## REMARKS

This Amendment is submitted in response to the Examiner's Action dated September 11, 2002, having a shortened statutory period set to expire December 11, 2002, extended to January 11, 2003.

# Proposed Drawing Changes

FIGURE 2

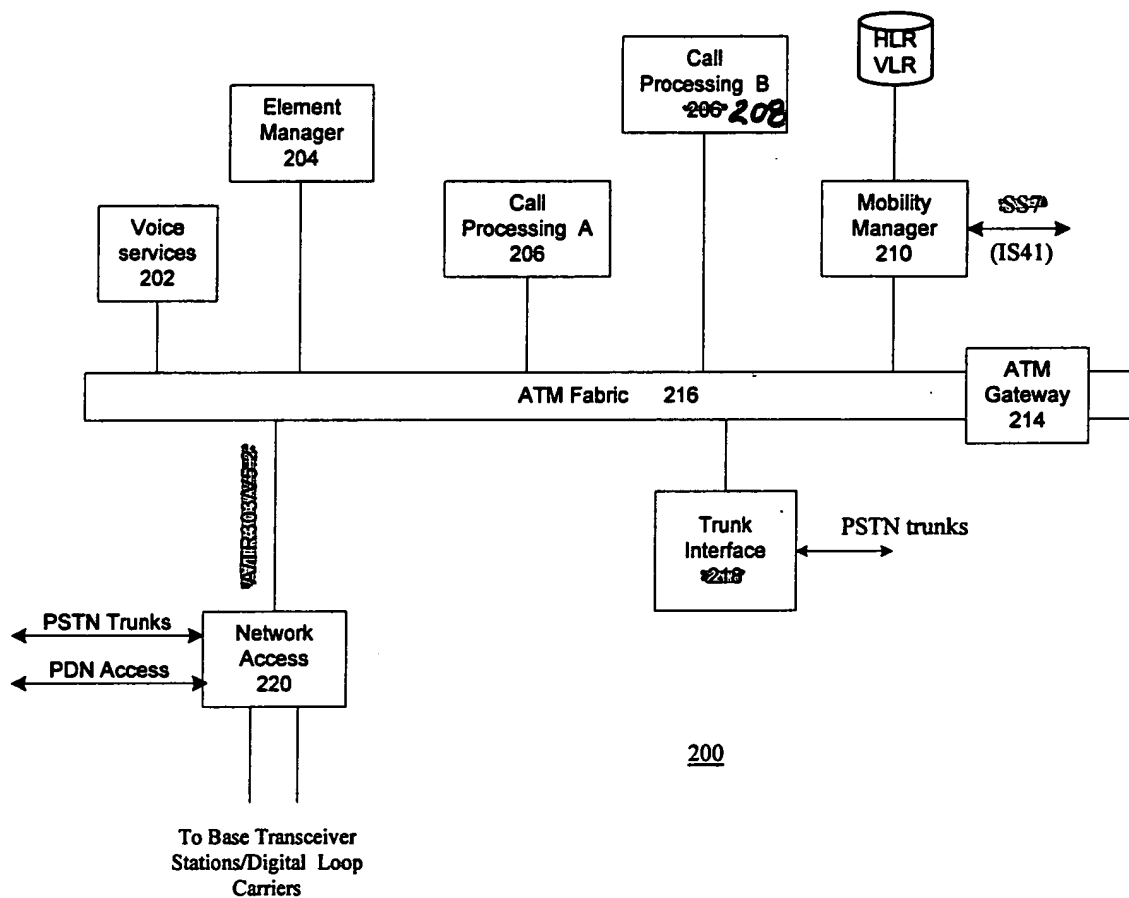
Next, the Examiner has objected to the drawings, noting that the drawings utilized the reference character "206" to designate both "Call Processing A", "Call Processing B" and a "Mobility Manager Function" in the written description at page 12, line 28. Applicant submits herewith a proposed drawing correction in which "Call Processing B" has been amended to utilize the reference numeral 208 and the specification has been corrected to modify the

description of Mobility Manager Function to conform that description to the drawings as previously submitted.

Finally, the Examiner objects to the drawings for a failure to include the "call process function 208" mentioned an amendment to the specification and a proposed correction to the drawings have been submitted to correct this matter. Finally, the reference to "see Figure 6" included at page 16, line 12 has been amended to correctly refer to Figure 2.
